## Contents List

**Hunter F. Mk. 6 Aircraft—Starter System—Exhaust Assembly revised**  
**Part (a) Lengthened Pipe, Part (b) Reinforcement Plate—Introduced**  
*by the introduction of a Reinforcement Plate.*  
**(MOD. NO. HUNTER 474.)**

Hunter F. Mk. 6 Aircraft—Trunnion Mounting Spigot Shortened Lug 0.05 in.

## Hunter F. Mk. 6 Aircraft—Starter Installation, Venting Introduced and Drain Improved

DRG. N° A.P. 4347F /P. 1 /56

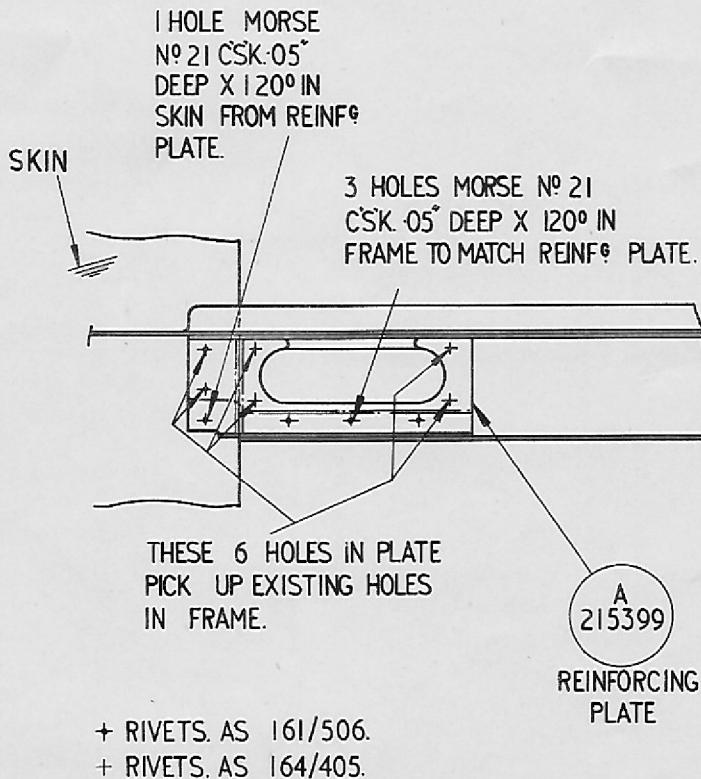
A lengthened exhaust pipe has been introduced in the Starter System to ensure that starter fuel is drained clear of the aircraft during ground testing. Also, a reinforcing plate has been fitted to the fuselage at the exhaust pipe aperture.

(7) Modify the door landing, Part No. E.200196/8 at bottom of Frame 27 as shown on the drawing.

DRG. No. A.P.4347F/P.3/57

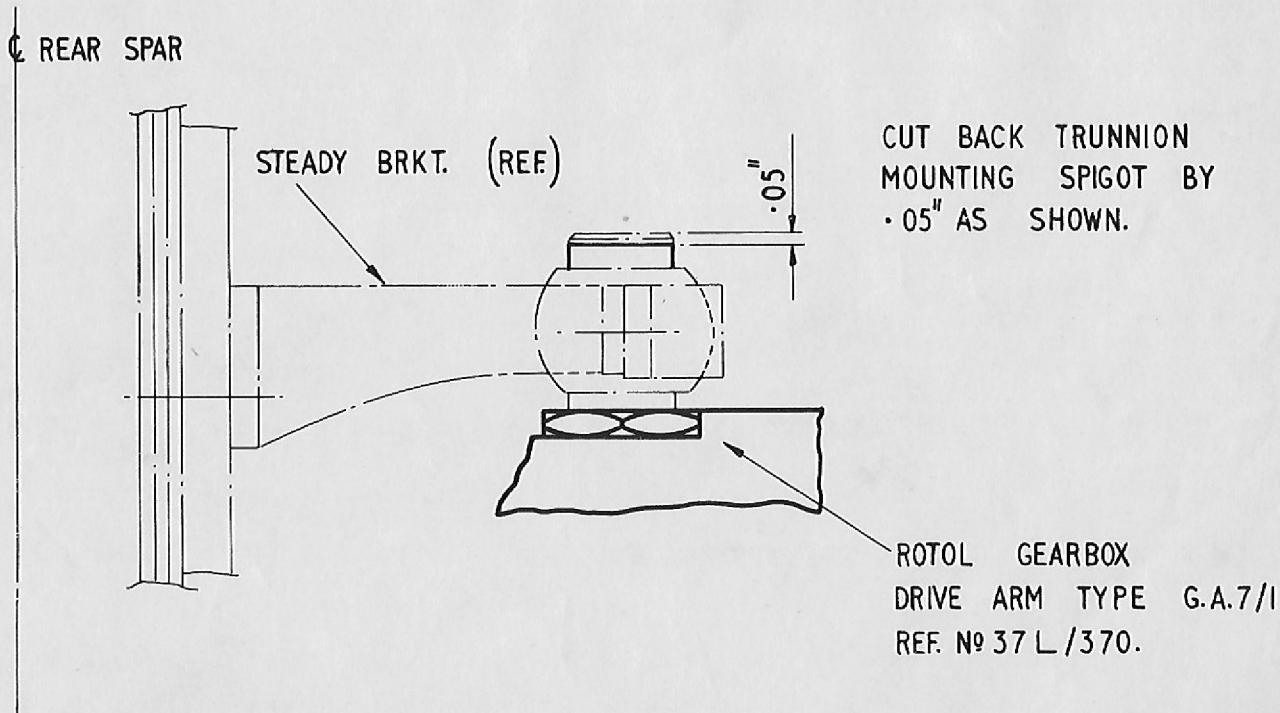
The clearance between the trunnion mounting spigot on the gearbox drive arm and the adjacent aileron control rod has been increased by shortening the spigot by 0.05 in.

- (1) With engine removed, locate the trunnion mounting spigot at the top of the accessory gearbox drive arm, Type G.A.7/1 (Ref. No. 37L/370).
- (2) Cut back the spigot by 0.05 in. as shown on the drawing.
- (3) Record the embodiment of Rotol Mod. No. G.B.1010 on the accessory gearbox modification plate.

DRG. No. A.P. 4347F/PS/59.

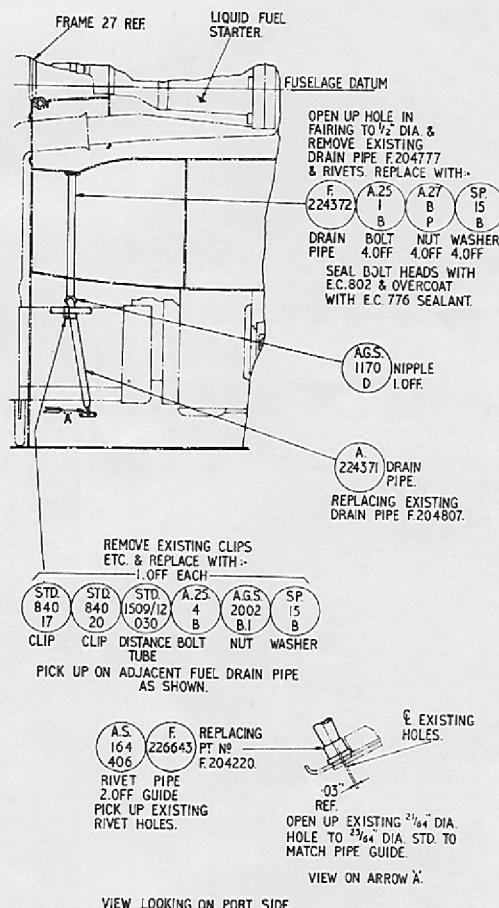
To prevent a concentration of I.P.N. fuel gases in the liquid fuel starter bay, a vent pipe from the gas fairing to atmosphere has been introduced and the drain pipe increased in size.

- (1) Remove engine (A.P. 4347F, Vol. 1, Section 4, Chapter 1 refers).
- (2) Remove drain pipes, Part Nos. F.204777 and F.204807 together with pipe guide, Part No. F.204220 and relevant clips and fixings, as shown on the drawing incorporated in this leaflet.

- (3) Modify the air intake fairing and fit new drain pipe top, Part No. F.224372, as shown on the drawing incorporated in this leaflet.
- (4) Modify the bottom skin and fit new pipe guide, Part No. F.226643, as shown on the drawing incorporated in this leaflet.

- (5) Fit new drain pipe bottom, Part No. A.224371, together with nipple, Part No. AGS.1170/D and relevant clips as shown on the drawing incorporated in this leaflet.

DRG. No. A.P. 4347F/P7/59

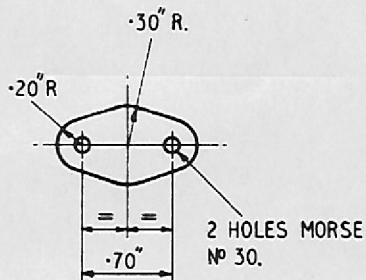
On embodiment of Plessey Mod. No. S.260, the gear-box drain on the starter motor is deleted, and, in consequence, the corresponding drain pipe in the airframe is no longer required.

- (1) From 18 s.w.g. light alloy plate, Spec. L.72, manufacture blanking plate, Part No. F.233802 as shown on drawing.

- (2) Remove the assembly of starter drain pipe, Part No. B.216464, together with relevant clips, between the starter motor and the bottom skin at frame 27.
- (3) Remove the pipe flange, Part No. F. 216465 from the bottom skin at frame 27 and blank off the redundant hole with blanking plate, Part No. F.233802 using rivets, Part No. AS.164/404.
